ADDITIONAL SERVICE REQUEST FOR PROFESSIONAL SERVICES

RE: City of Hallandale Beach

EV Bus Charging Stations – Standalone Phase 1 CDs

SMA #2022-184 AS03

CANOPY #1 - FLOOR PLAN

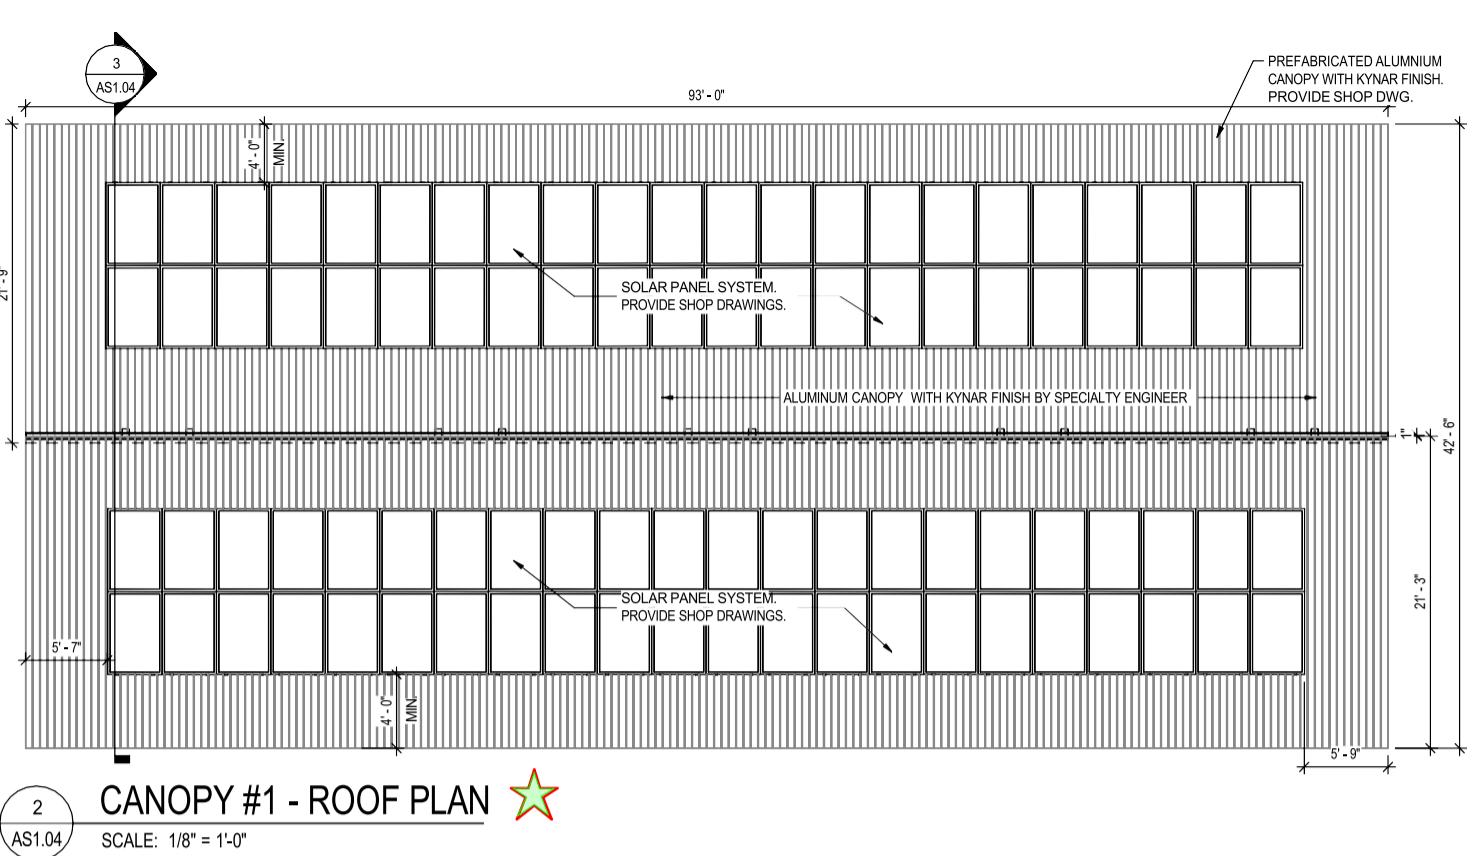
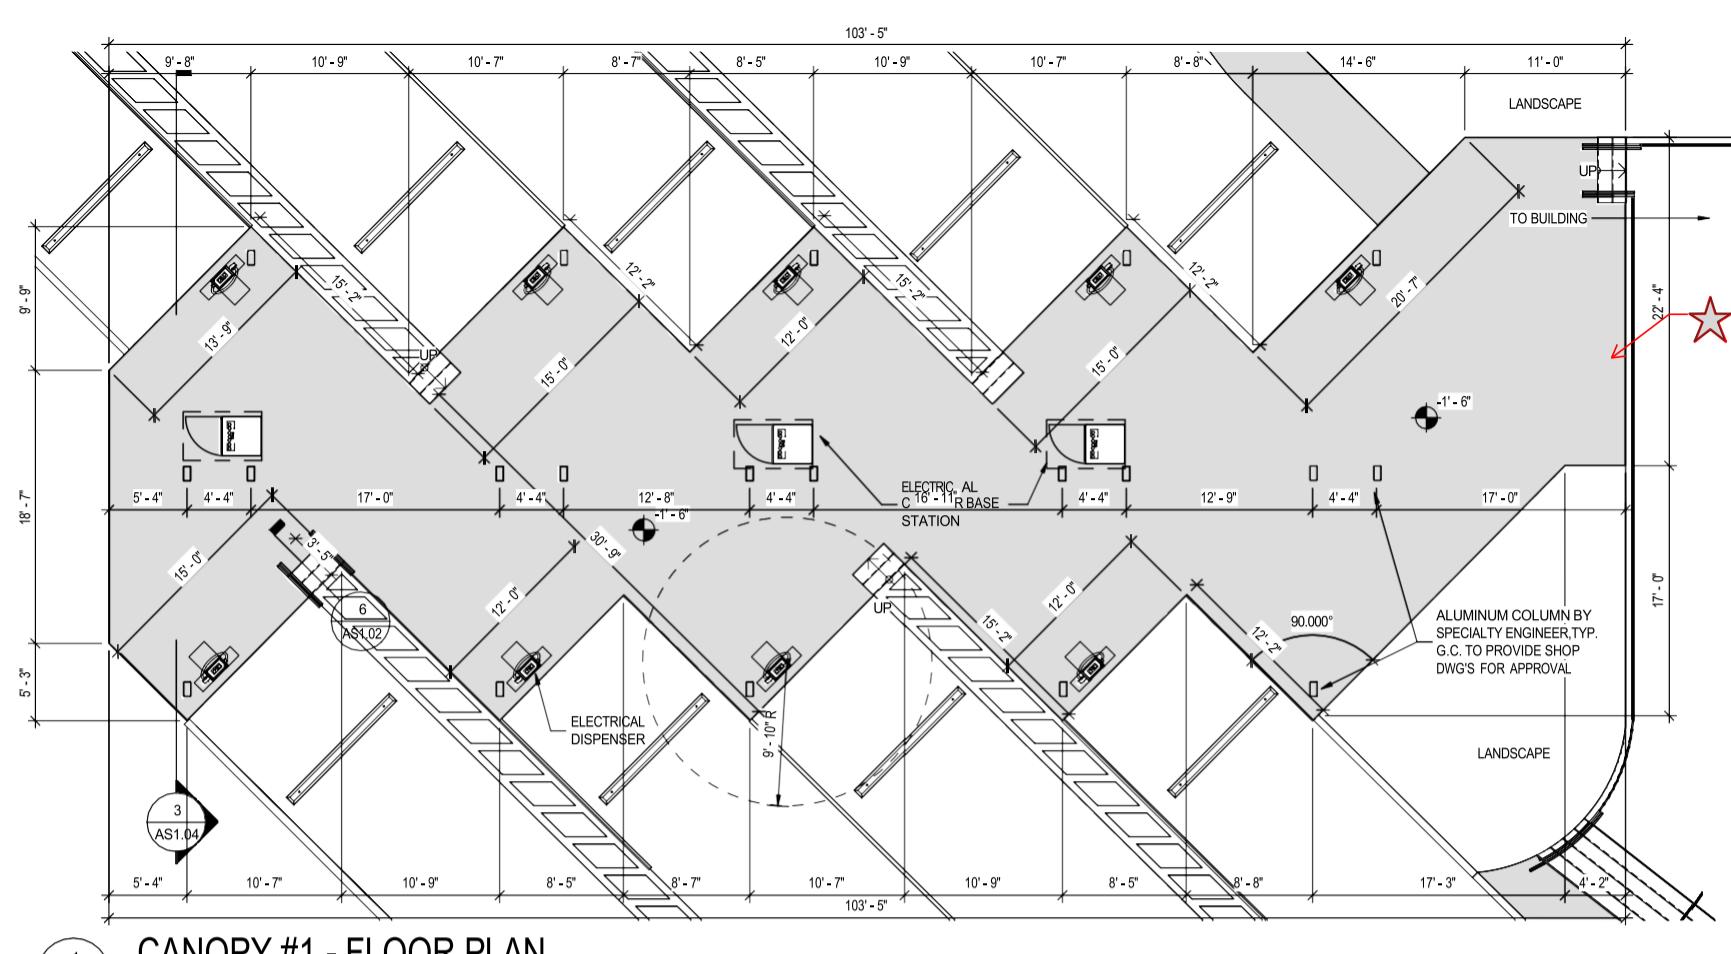
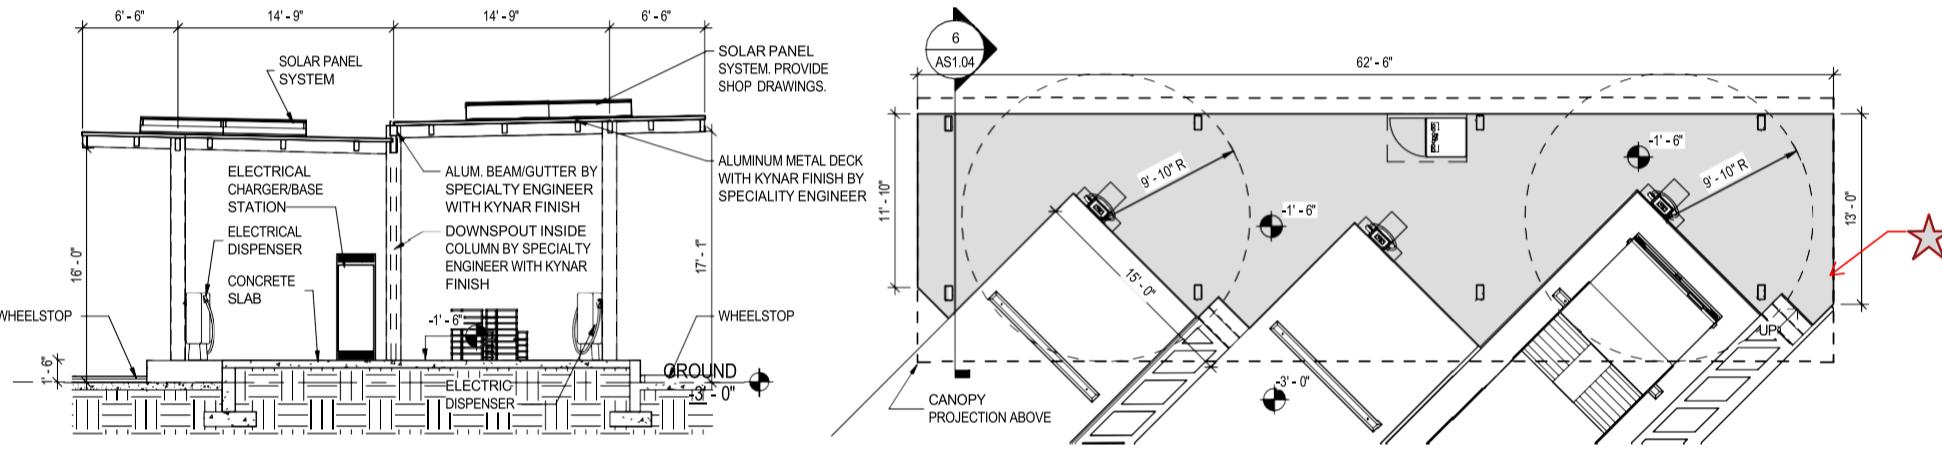
1. Eliminate from the project, all solar panels and all related components installed atop all canopies, including mounting hardware, electrical wiring, inverters, disconnect switches, and any associated conduit or support structures required for their operation and integration into the site's electrical system.
2. Remove the large aluminum canopy identified as Canopy #1 from the project, including the complete aluminum framing, roofing materials, fastening systems, and all associated structural components, as well as the removal of the aluminum canopy concrete foundations, footings, and anchorage elements that support the canopy. Add the

installation of foundations and anchor bolts for the proposed alternate Canopy #1 to be installed in the future. Canopy design and connections to be coordinated with the City.

CANOPY #2 - FLOOR PLAN

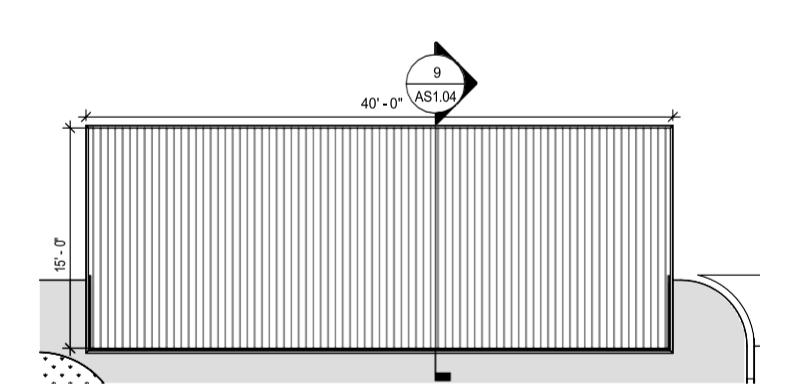
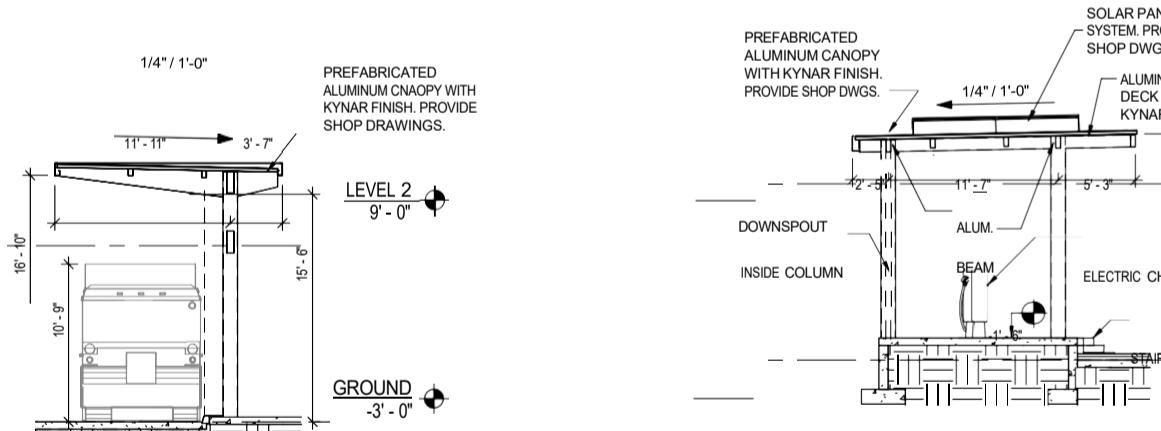
3. Remove the West aluminum canopy known as Canopy #2 from the project, comprising the aluminum framework, roofing materials, fasteners, and related structural elements. This includes removal of the aluminum canopy concrete foundations, footings, and any anchoring systems necessary for canopy stability and structural integrity. Add the installation of foundations and anchor bolts for the proposed alternate Canopy #2 to be installed in the future. Canopy design and connections to be coordinated with the City.

4. Remove from the project, all concrete elevated slabs, access ramps, stairs, handrails, guardrails, and any other associated site improvements located at Canopies #1 and #2. Reduce the area of the currently proposed elevated slab so that the new proposed alternate Canopy #1 and Canopy #2 width can be reduced from approx. 42ft to approx. 24 ft in width. Add D Curb and Slab on grade with thickened edges where all concrete elevated slabs were removed and raised platforms at locations of EV charging equipment.

BUS WASH CANOPY - FLOOR PLAN

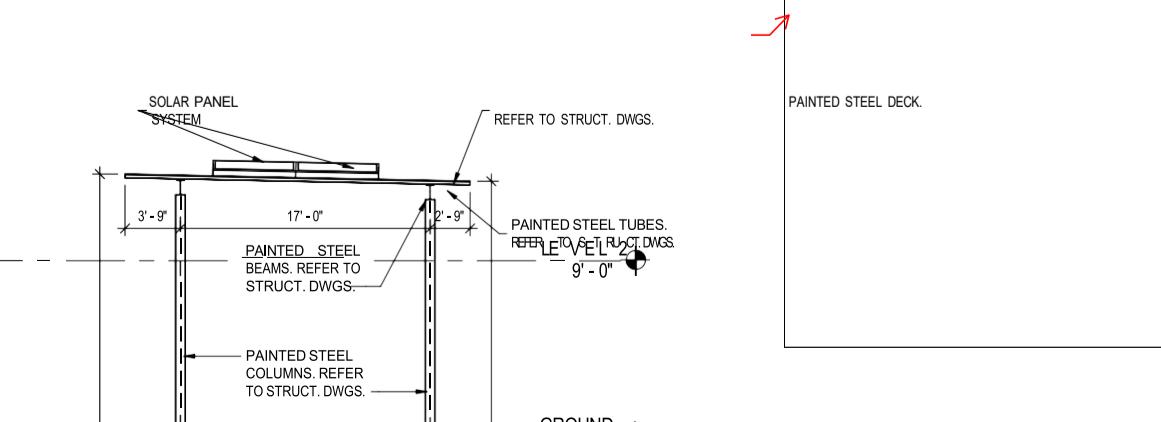
9. Remove the concrete pavement driveways and parking areas from the project and replace with asphalt pavement, throughout the designated site areas including the bus wash area. A new bus wash area is no longer proposed and additional parking spaces will be designed in its place. This includes demolition and removal of concrete slabs, preparation of subgrade and base layers, asphalt paving installation, compaction, and final surface treatments to meet specified performance standards.
